K-2 Difference statement

K-2 modify:

2. Modify PCBA(Modify K-2 For 0.2C PCB)

1. Appearance change:

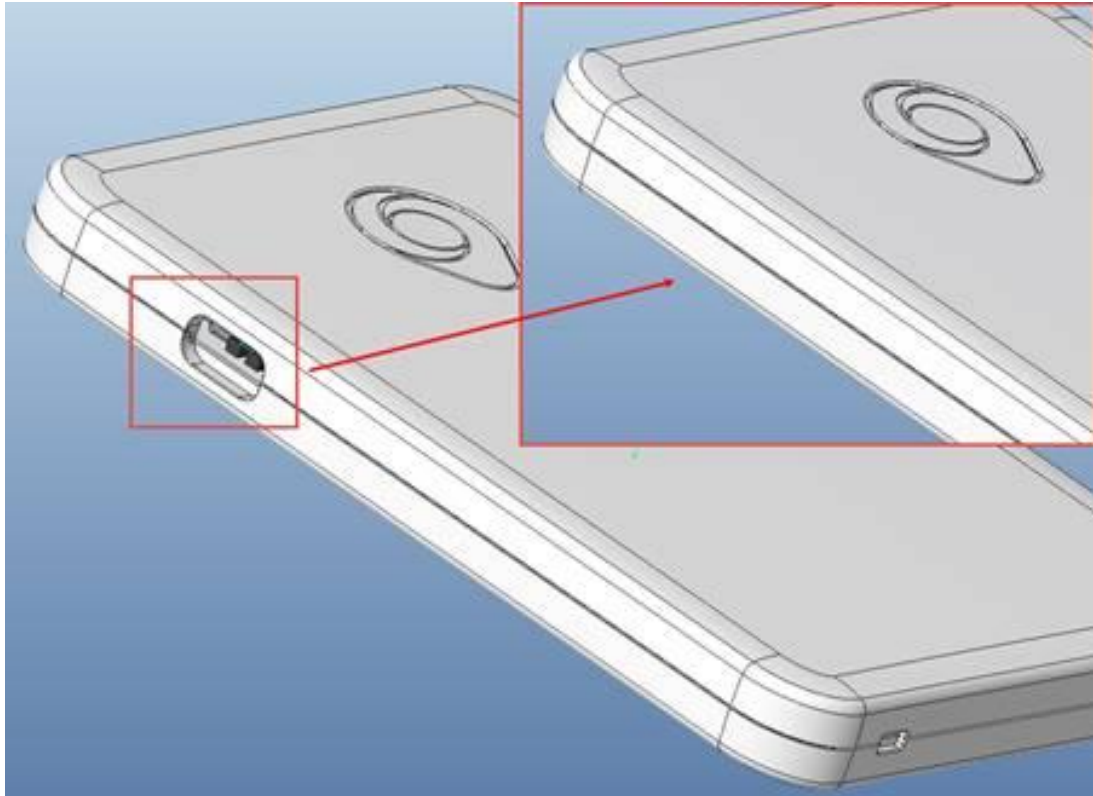
There are no changes in the material, only the appearance changes: as shown below

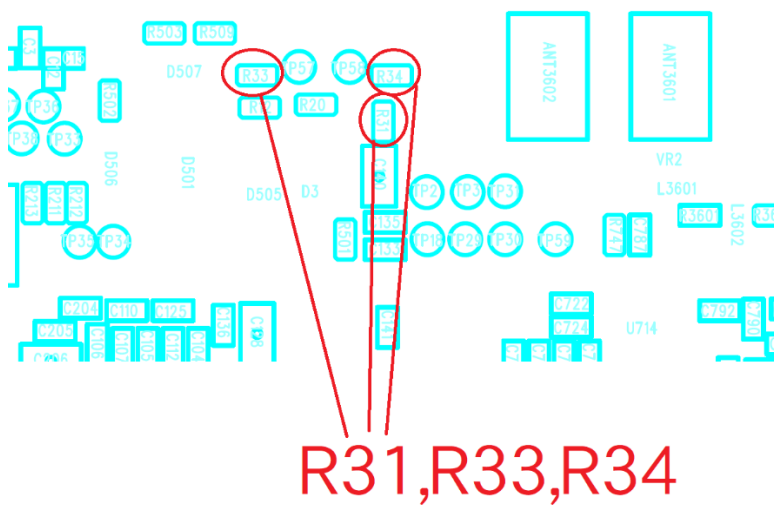
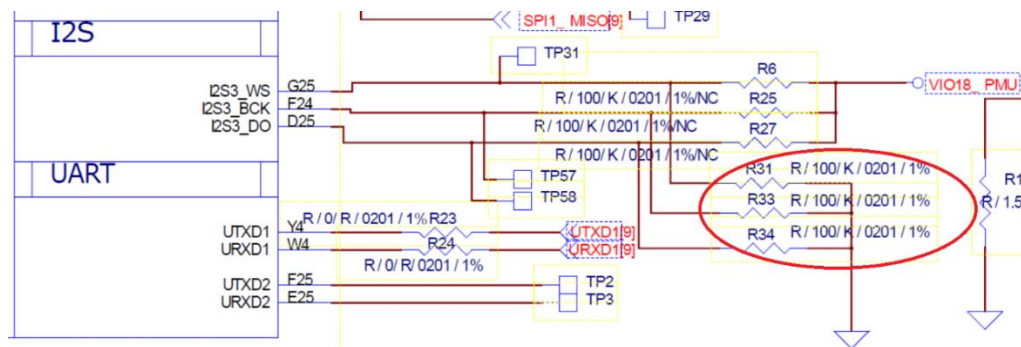
1. Added 3 resistors to confirm the version,R31,R33,R34,

1	WT2N	Hardware Ver. Control	Add pull low resistance to check HW Ver. MTK U402 I2S3_WS(G25), I2S3_BCK(F24),I2S3_DO(D25), PCB version,PULL HIGH100K Ω,VIO18_PMU, with PULL LOW 100K Ω to GND Actually the pieces are: U402_I2S3_WS(G25),PULL LOW U402_I2S3_BCK(F24),PULL LOW U402_I2S3_DO(D25),PULL LOW
---	------	-----------------------	--

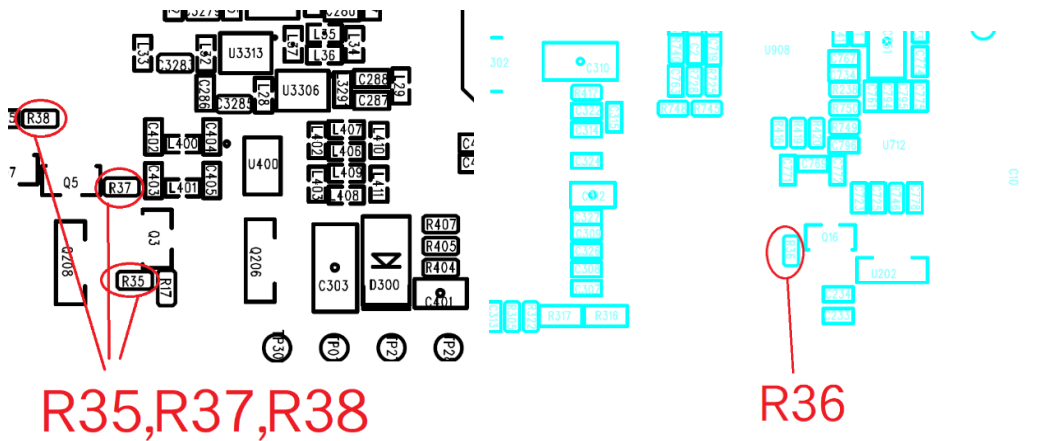
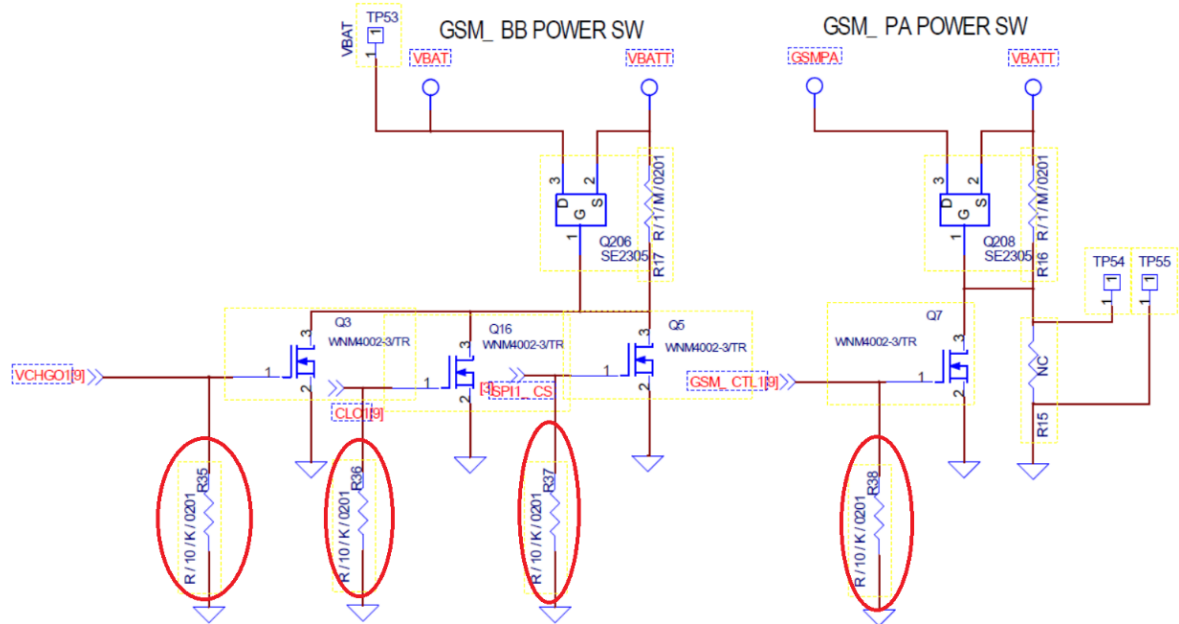
2	WT2N	Power Leakage When Off Siwitch	Add pull low resistance to shut down VBATT power Because it cannot be completely shut down, it must be 1.Q3' s G PIN parallel $10K\Omega$ to GND 2.Q160' s G PIN parallel $10K\Omega$ to GND 3.Q5' s G PIN parallel $10K\Omega$ to GND 4.Q7' s G PIN parallel $10K\Omega$ to GND
---	------	-----------------------------------	--

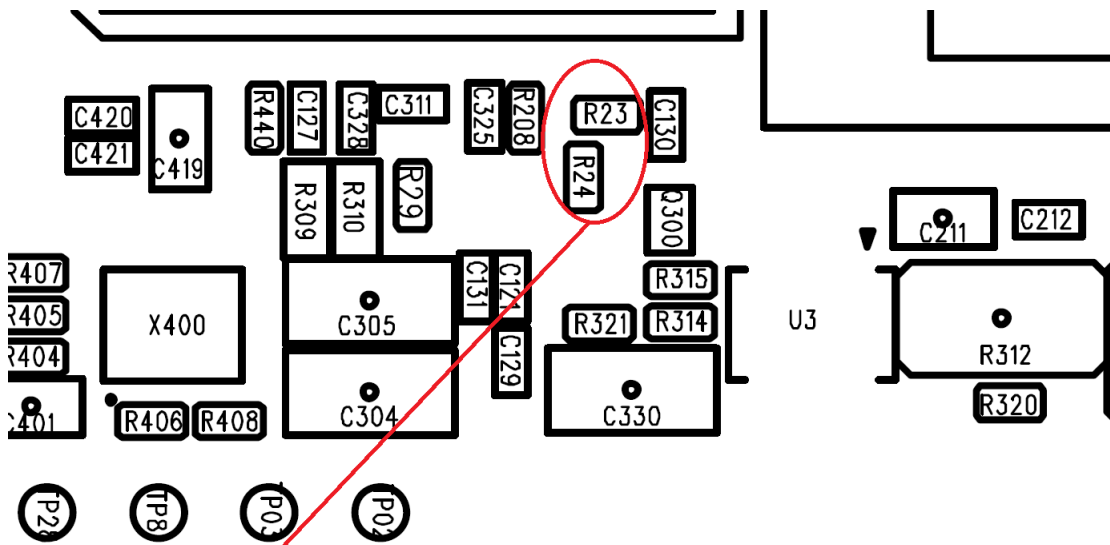
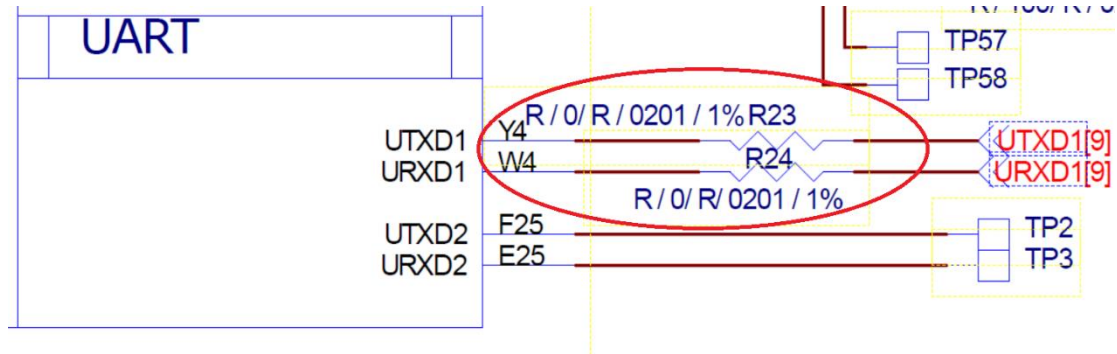
3	WT2N	UART Slew Rate	Resistance value change to 0Ω For UART R23 and R24 Change the resistance to 0Ω
---	------	----------------	---

$R23=0\Omega, R24=0\Omega$

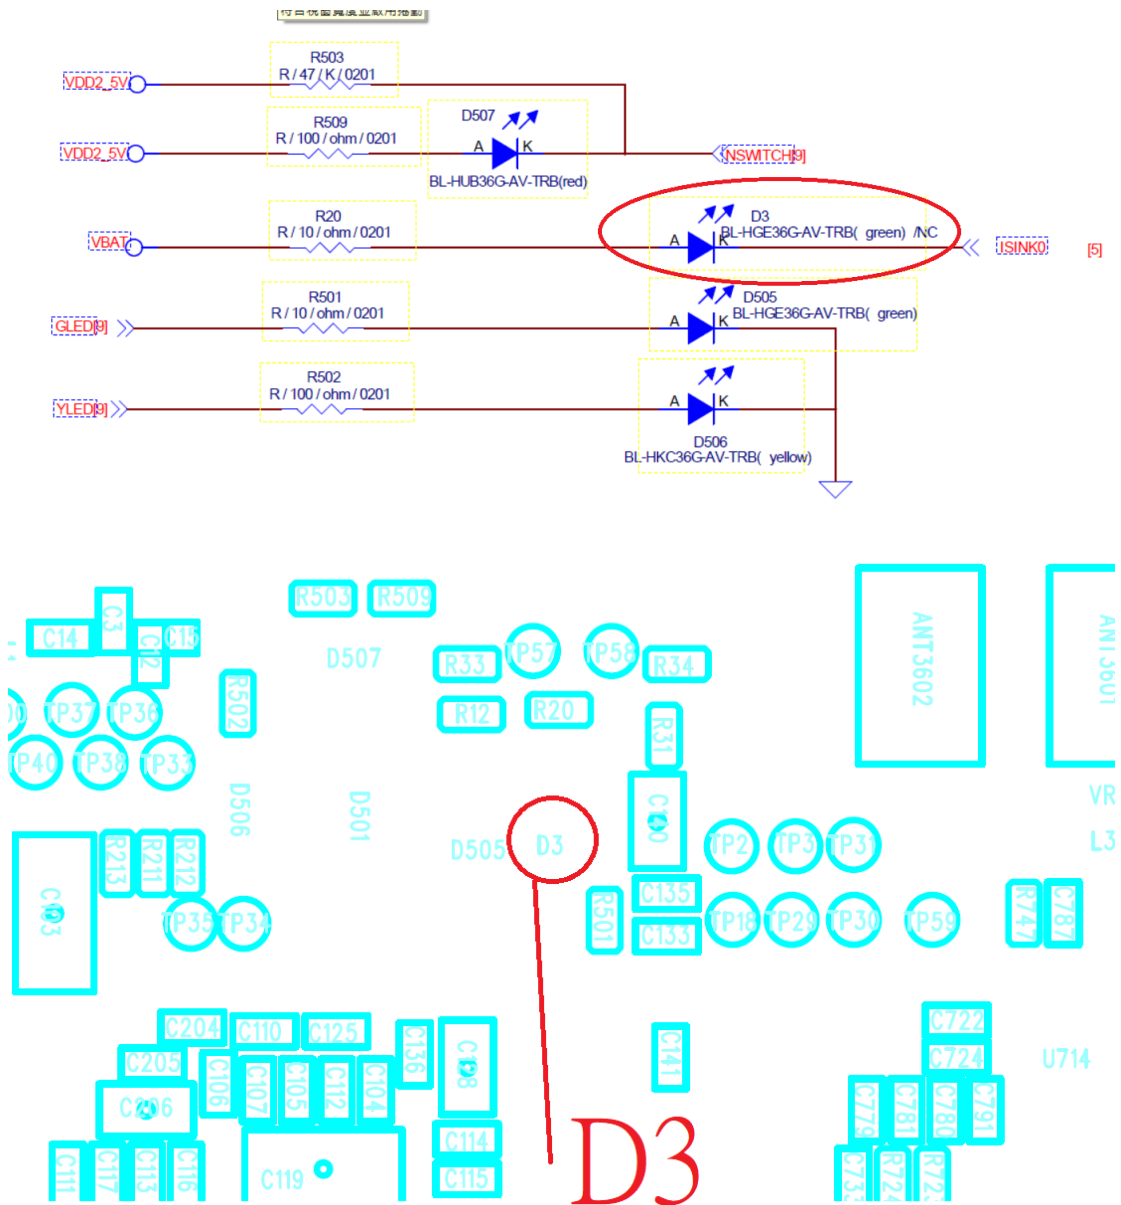
5	WT2N	4th LED removed	Take off D3
---	------	-----------------	-------------

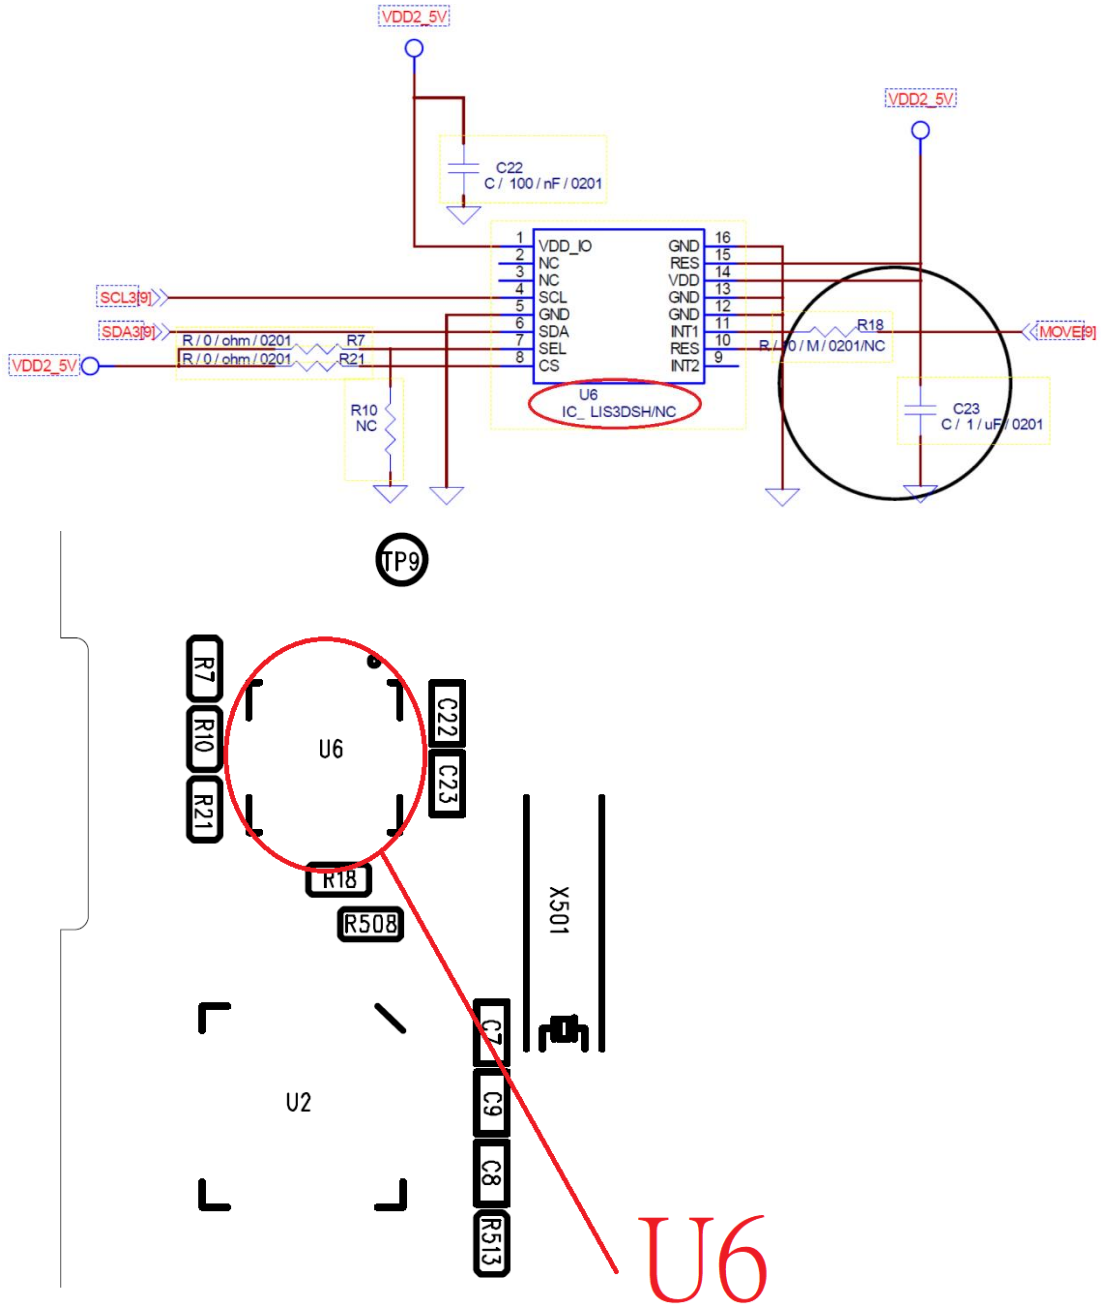
6	WT2N	Accelerometer removed	Take off U6
---	------	-----------------------	-------------
